Project	IEEE 802.20 Working Group on Mobile Broadband Wireless Access	
	< http://grouper.ieee.org/groups/802/20/ >	
Title	Response to C802.20-06-14r1.	
Date Submitted	2006-05-05	
Source(s)	Jim Tomcik Qualcomm, Incorporated 5775 Morehouse Drive San Diego, CA, 92121	Voice: (858) 658-3231 Fax: (858) 658-2113 Email: jtomcik@qualcomm.com
Re:	IEEE 802.20 session #20, May, 2006	
Abstract	This document provides responses to the questions concerning MBFDD and MBTDD Wideband Modes, posed in contribution C802.20-06-14r1.	
Purpose	FYI.	
Notice	This document has been prepared to assist the IEEE 802.20 Working Group. It is offered as a basis for discussion and is not binding on the contributing individual(s) or organization(s). The material in this document is subject to change in form and content after further study. The contributor(s) reserve(s) the right to add, amend or withdraw material contained herein.

During the March Plenary meeting of 802.20, a contribution (C802.20-06/14r1) was submitted with a list of questions on the confirmed 802.20 proposals. This document provides responses to those questions dealing with the FDD and TDD Wideband Mode technologies.

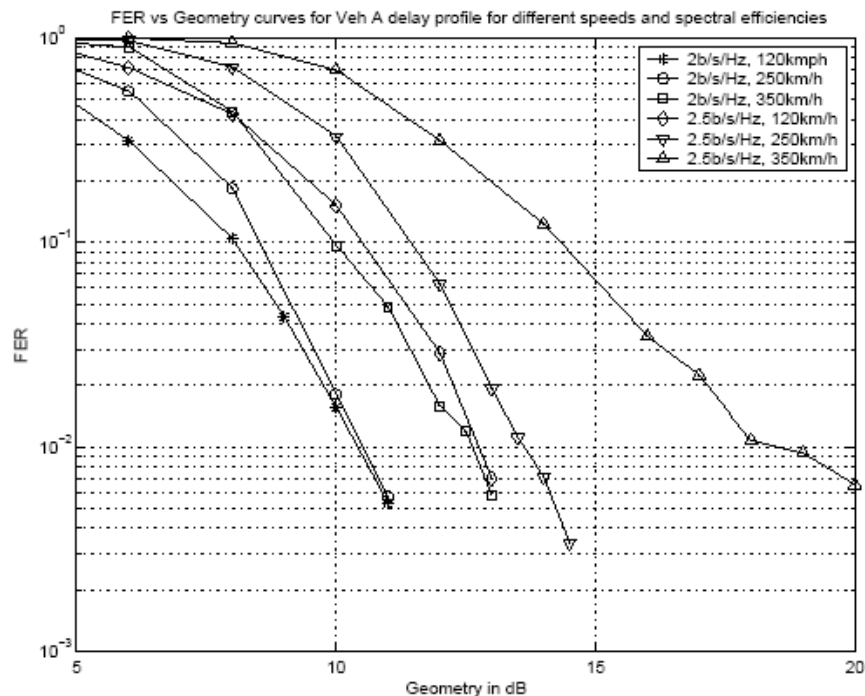
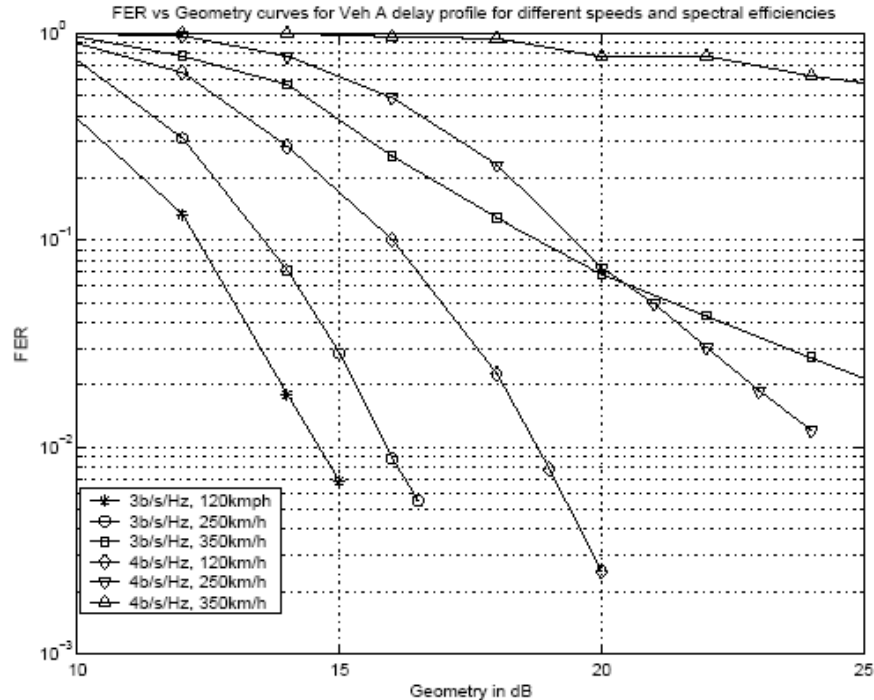
- The subcarrier spacing of 9.6 kHz may be inadequate to support fast channel environment. What is the speed limit for feasible operation? Could you show the simulation result supporting this?

Response: The two figures below show the performance of different spectral efficiencies on a Rayleigh fading channel with an ITU Veh A delay profile at different speeds. These simulations incorporate the effects of Doppler ICI and actual channel estimation. As can be seen from these plots, the system is capable of supporting 2 b/s/Hz even at 350 km/h. Up to 3 b/s/Hz can be supported at 250 km/h, and 4 b/s/Hz can be supported at 120 km/h. Thus we can conclude that system performance degrades gracefully with increasing speed.

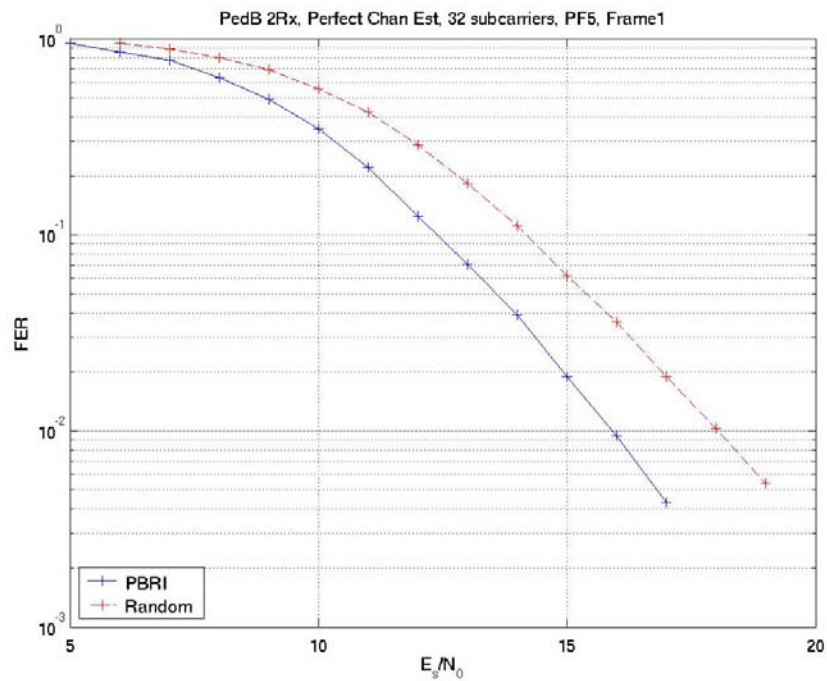
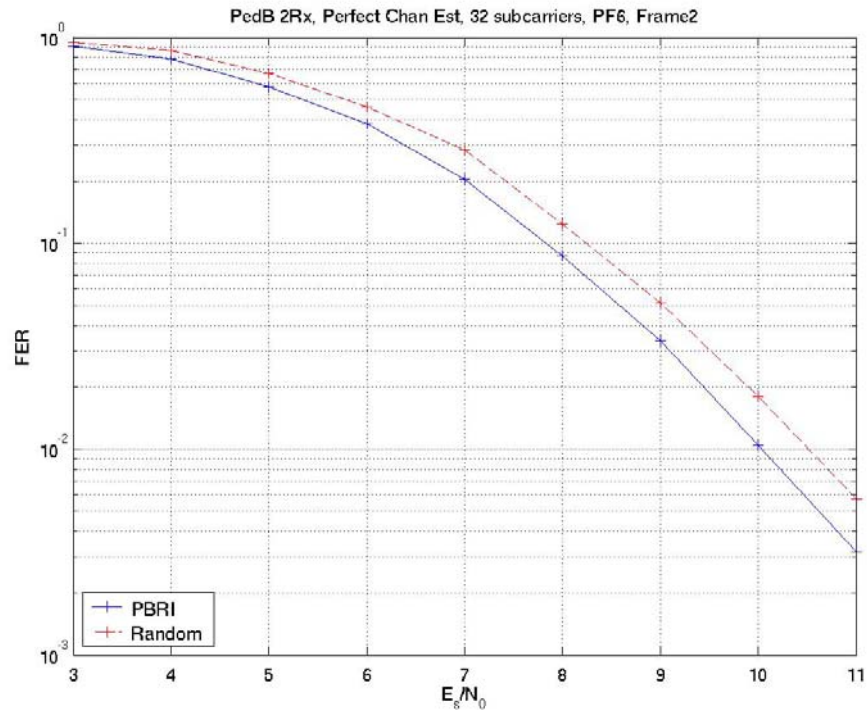
- 30 8. Slide 58 of contribution 05/64, the maximum C/I is shown to be less than 20 dB, has
31 this plot already included fast fading? Which channel model is used?

32 Response: This plot doesn't include fast fading, hence, no specific channel is used.

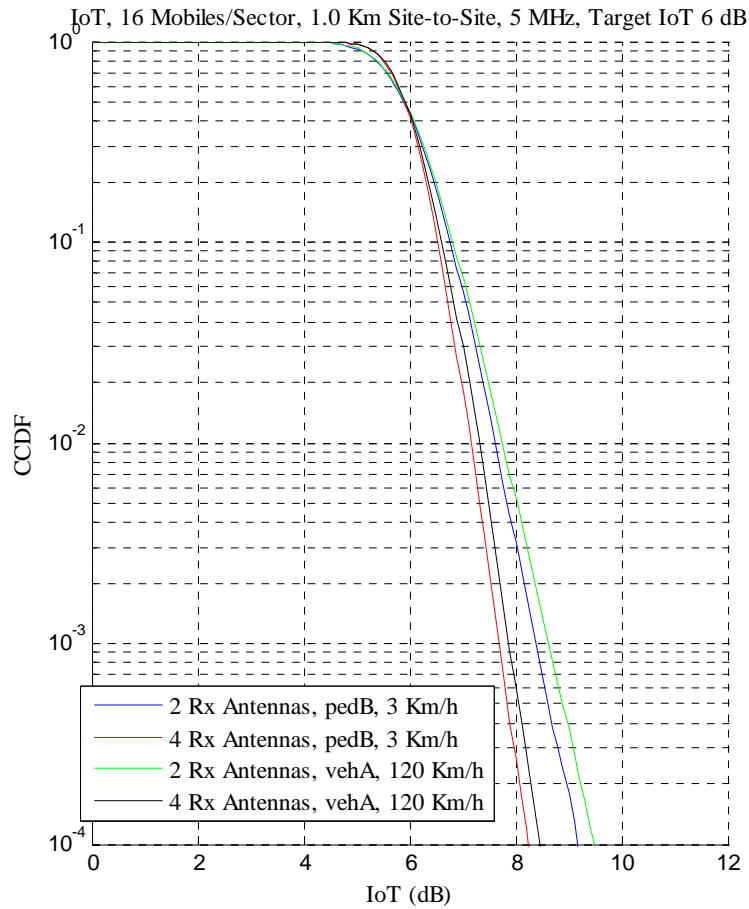
- 28 23. In contribution 05/61, CCDF of IoT is simulated for Pedestrian B, 3 km/h channel
29 model case only, how about the performance at higher mobility cases?

30 Response: The IoT distribution for the case of Vehicular A channel at 120 Km/h is
31 presented in the figure below, and is compared to the corresponding distribution with
32 Pedestrian B channel at 3 Km/h.

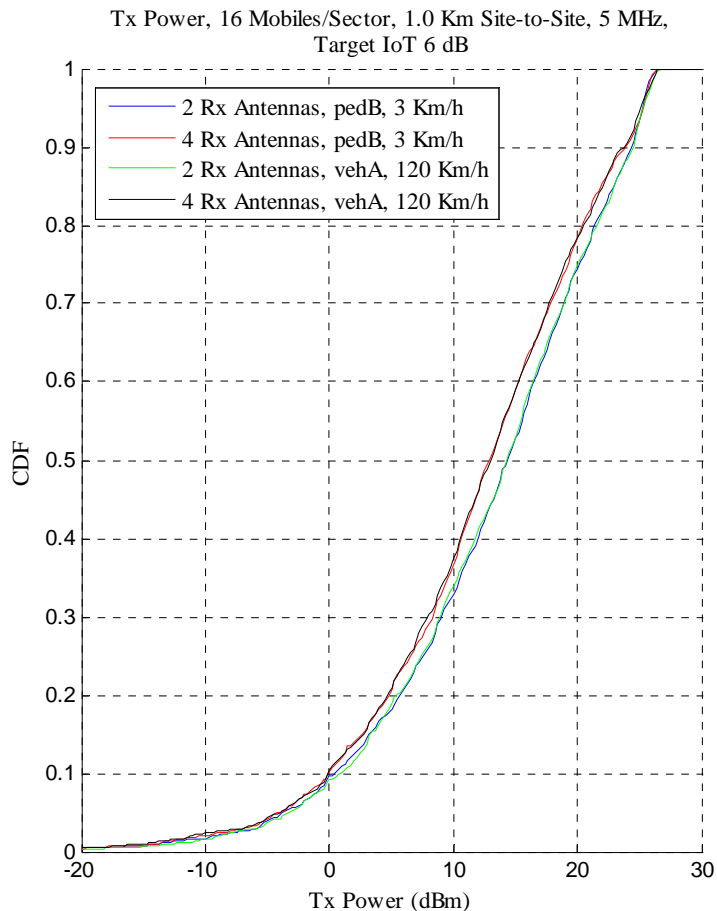
- 11 27. What does the distribution of user transmit power in the RL look like?

12 Response: The CDF of the mean user transmit powers for an example situation is
 13 shown in the figure below. This is for the case of a full-buffer simulation, with the
 14 parameters provided in the legend.
